Submittal Review Form

Project Number: 72XX	Submittal Ref. No: 72XX-Design Overview Submittal
Project Name: Armada Leviathan MDC	Submittal Title: Leviathan MDC-Design Overview Submittal
Date Submitted: 20/03/2026	Rev. No.: A

72XX-Armada LEVIATHAN Liquid Cooled Modular Data Centre

Design Overview Submittal - REV A

Drawn: AH	Model No: TBD	Serial No: N/A	Job No: 72XX
Checked: SB	Scale: N/A	Sheet: 01	Dwg. No: 72XX-GA-01

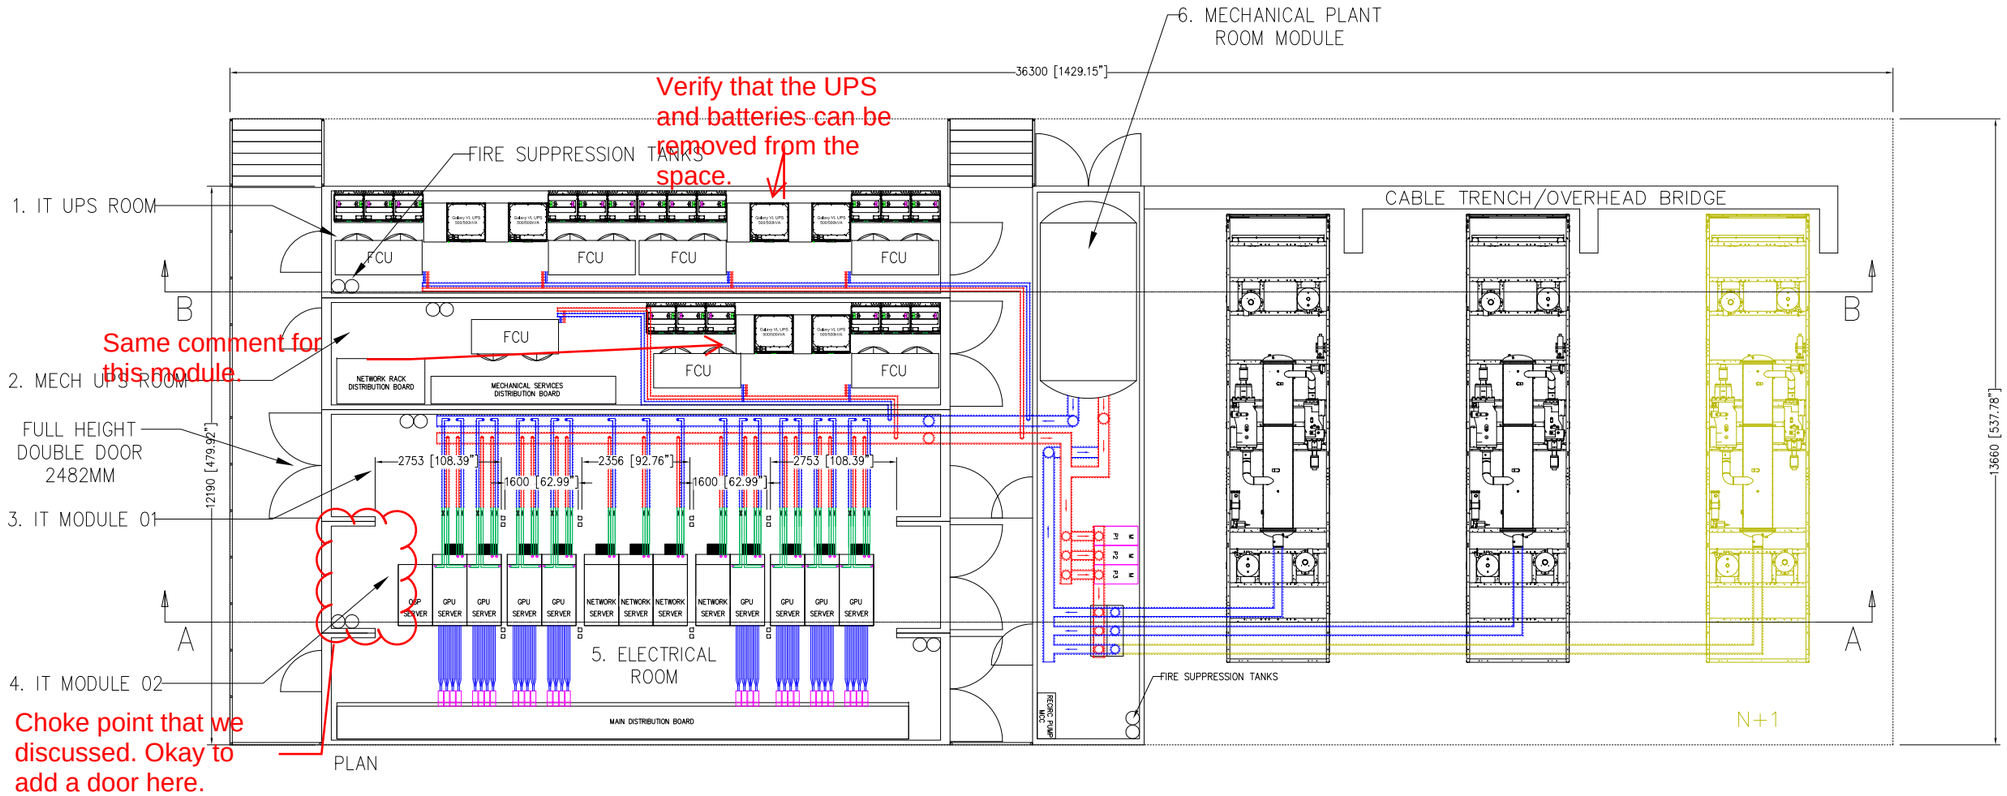
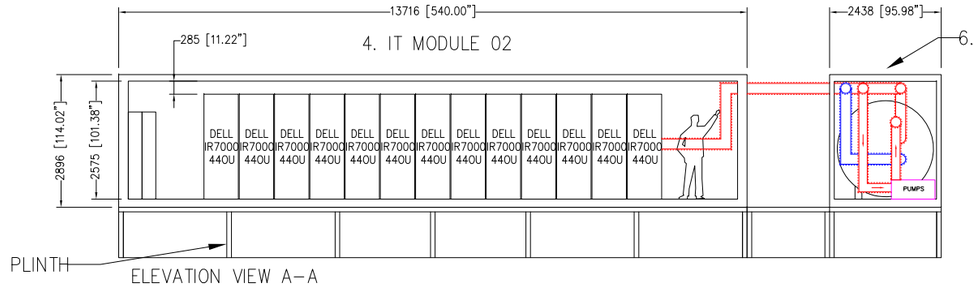
Is this point routable with Cable tray or however we intend to get the cables from one module to the next?

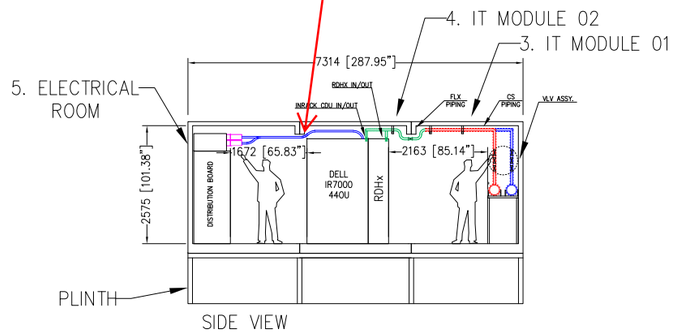
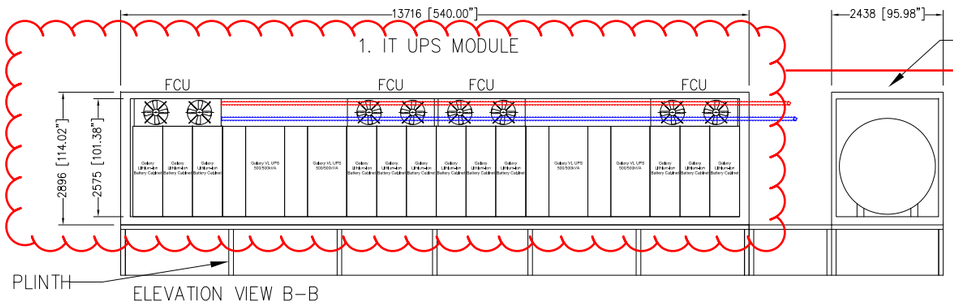
How do we get UPS in and out of the box, when based on this, the bottom of the FCU and the top of the UPS are basically the same height?
